**MEETING AGENDA OF THE
PLANNING COMMISSION OF THE TOWN OF FRISCO
FRISCO TOWN HALL
1 MAIN STREET
FRISCO, COLORADO 80443
APRIL 16, 2026
5:00 PM**

**PLANNING COMMISSION
STAFF REPORT**

AGENDA ITEM: Planning File No. MODSP-26-0001: A modification to MAJ-24-0005 and CU-24-0001 to make modifications to the proposed building materials, number of decks, number of windows, along with other minor modifications described in the applicant’s narrative.

LOCATION: 200 N 7th Ave / Lot E-2 River Pines Sub Resub Outlot E Replat A River Pines

©2025
 SHEET NUMBER:
A2.0
 BUILDING ELEVATIONS

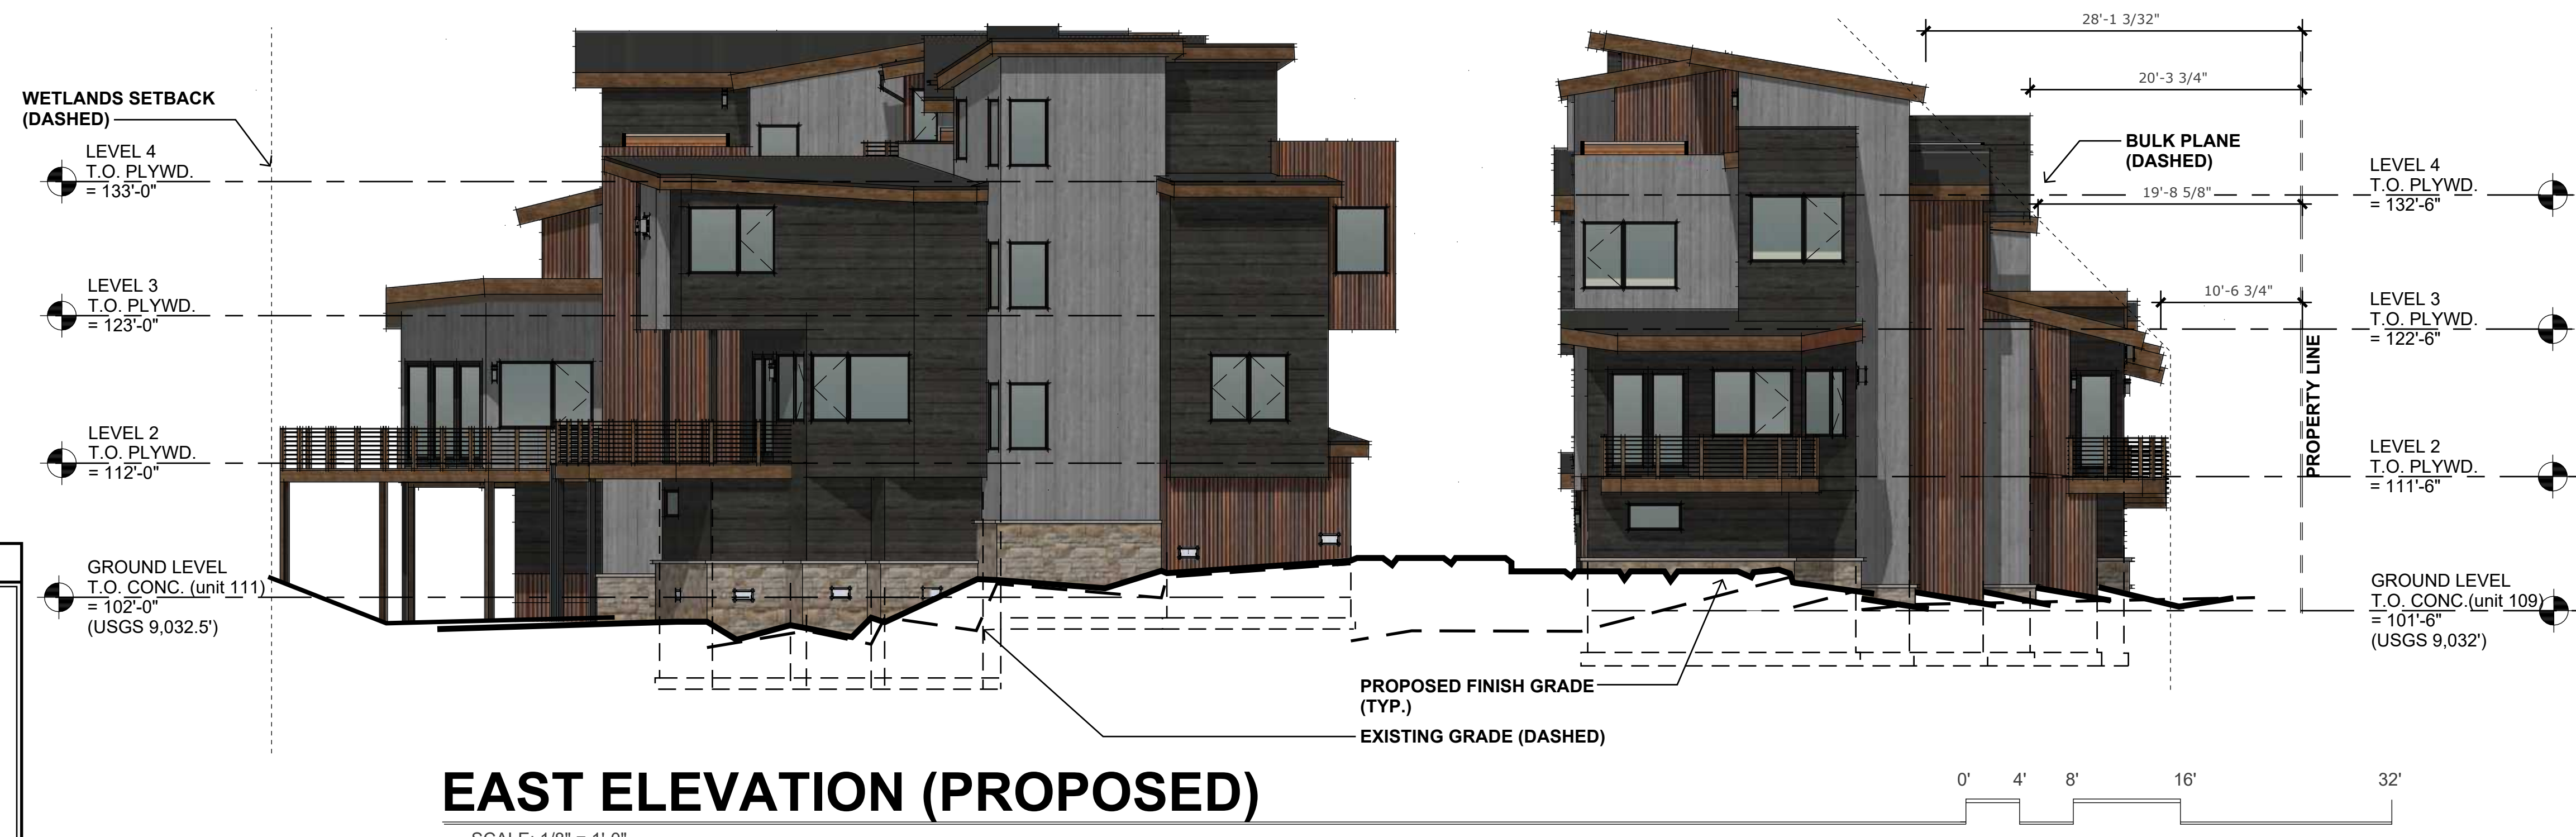
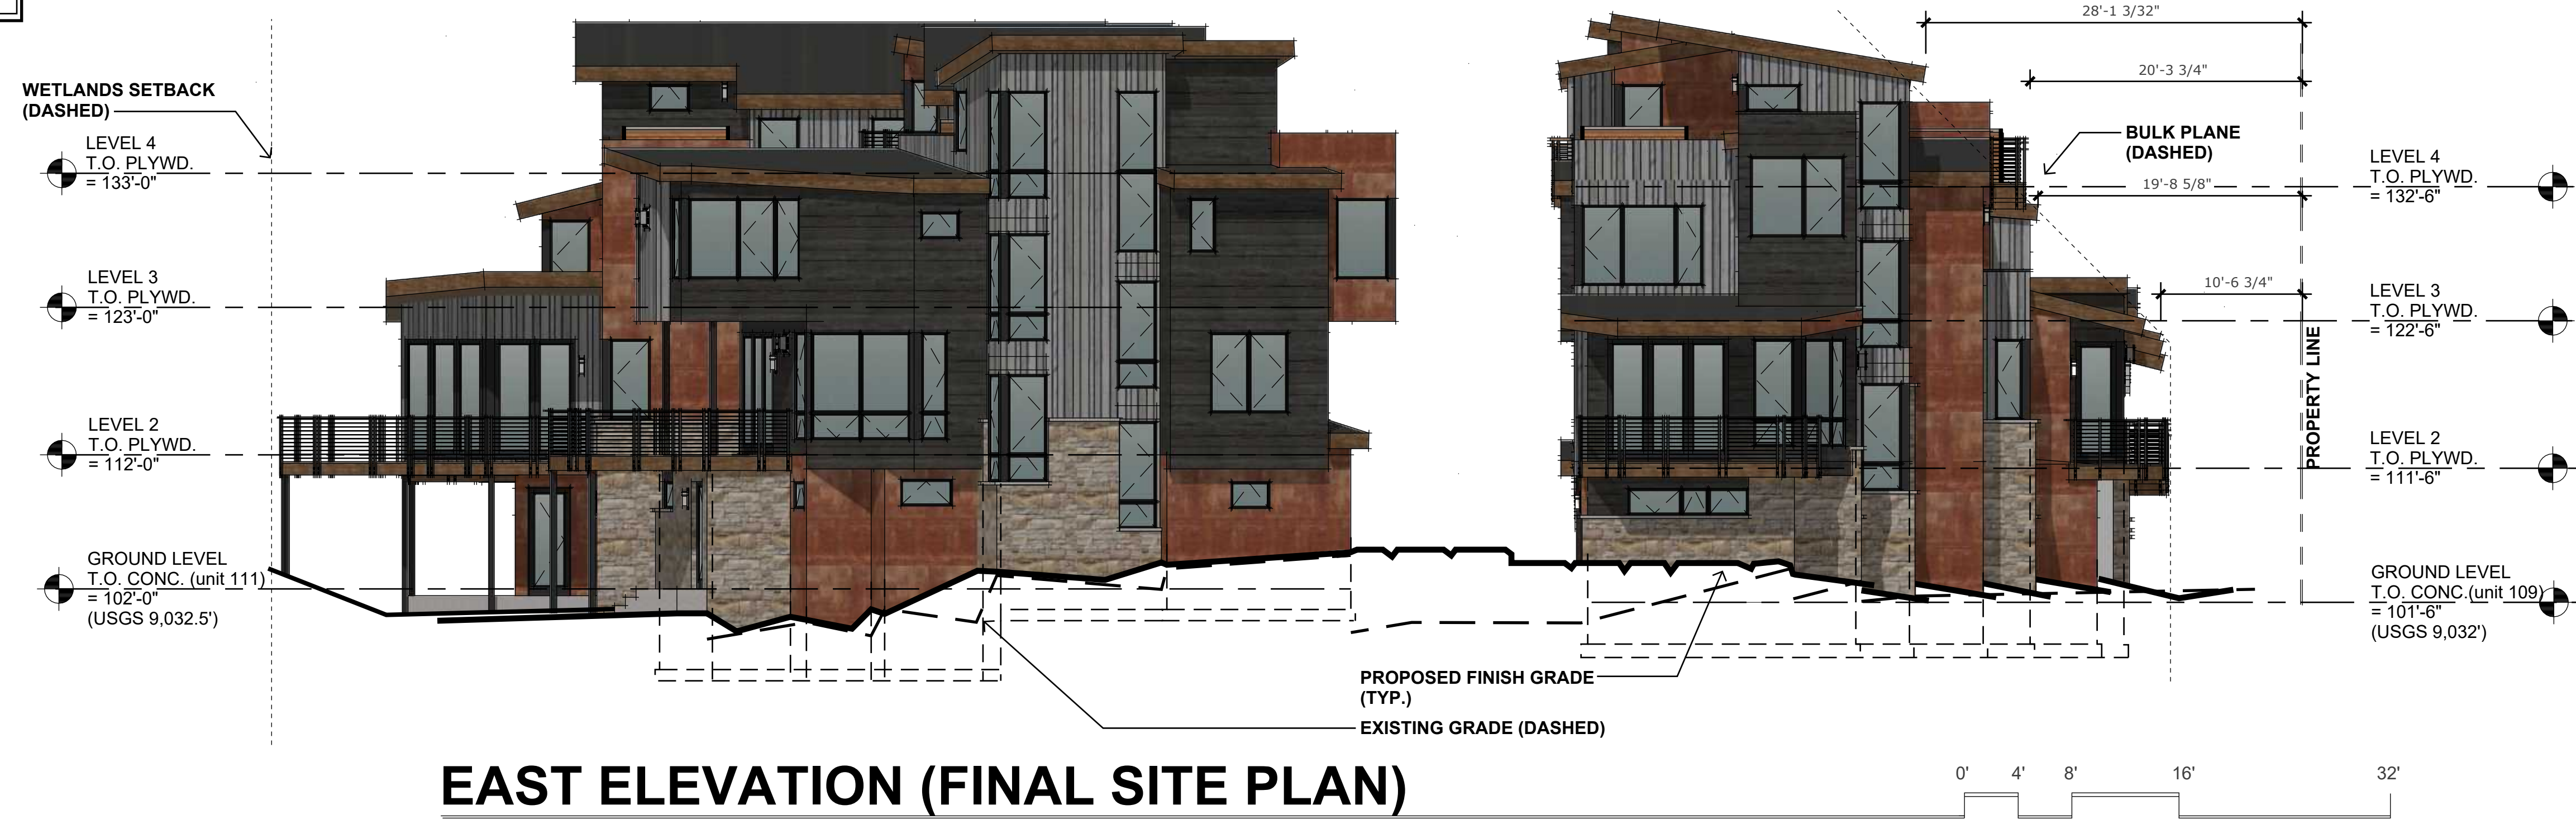
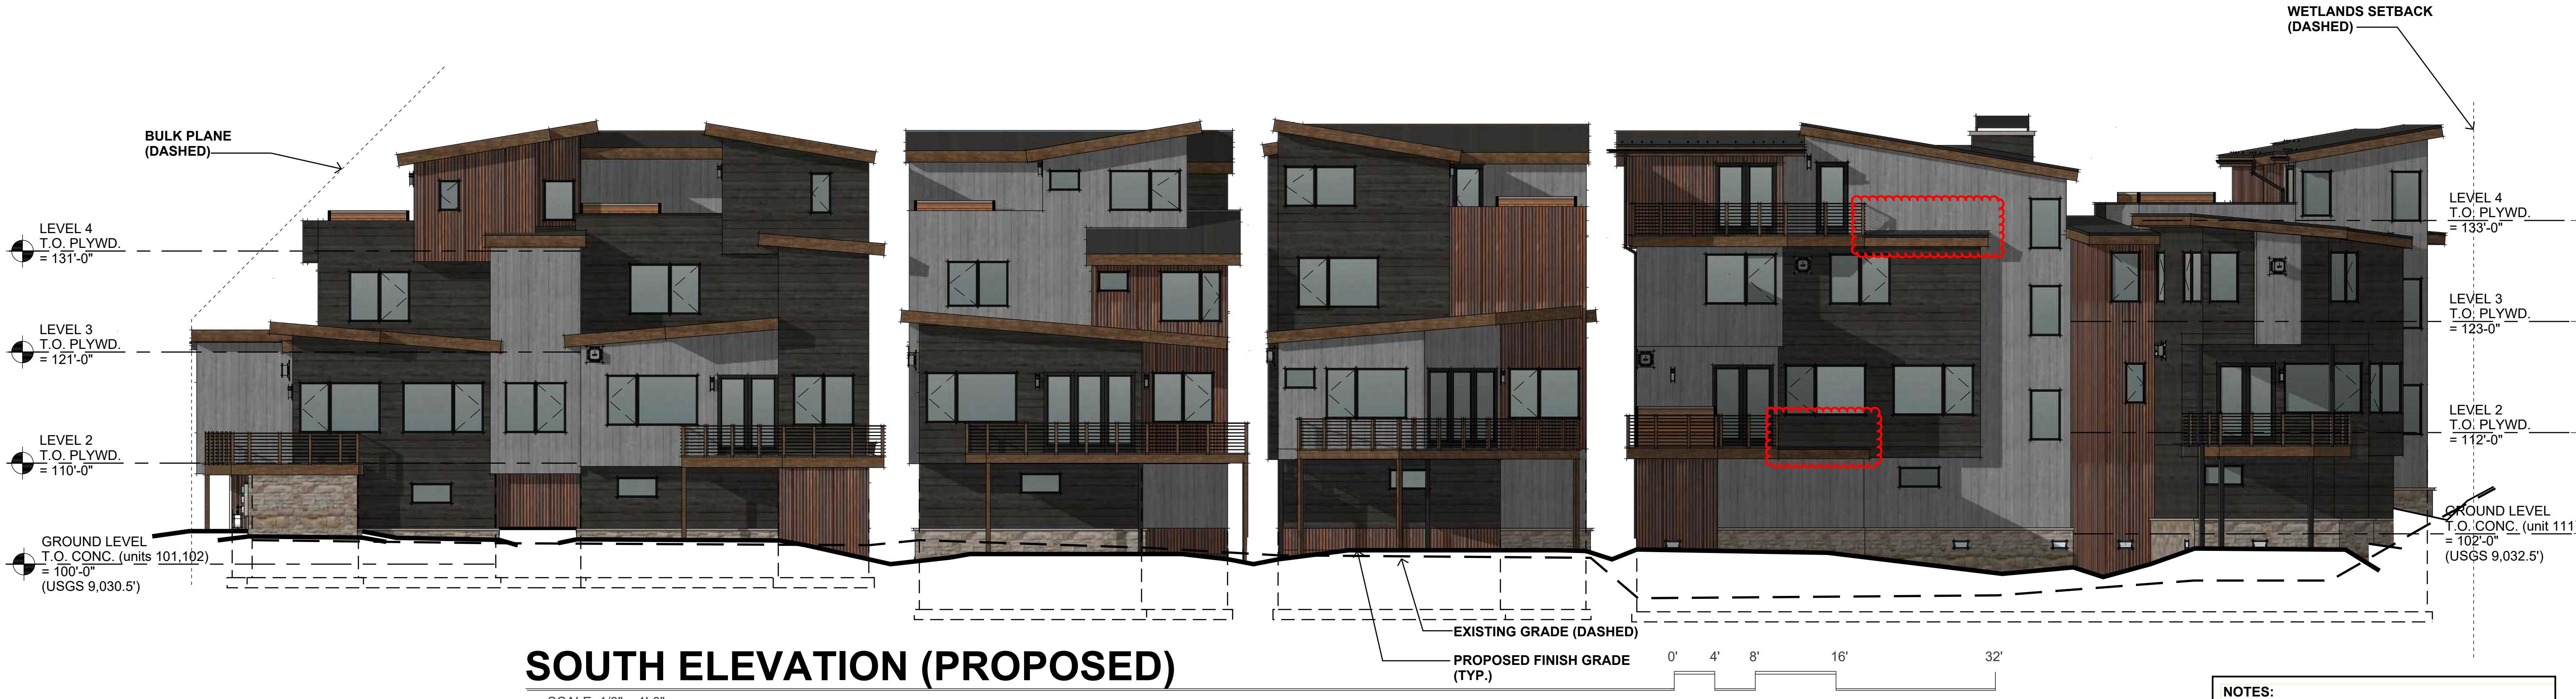
8. Windows

The Application proposes to reduce the overall number of windows compared to the previously approved final site plan. Please see Attachment A – Application, sheets A2.2 to A2.4, Building Elevations, several upper-level windows have been removed and replaced with solid walls. Staff has determined that the reduction in windows still meets the 180-6.22.3.A Façade Standards.

- Exterior siding modifications
- Reduction in the number of windows and overall window sizes
- Railing material modification
- Fourth floor roofing material modification
- Removal of certain decks
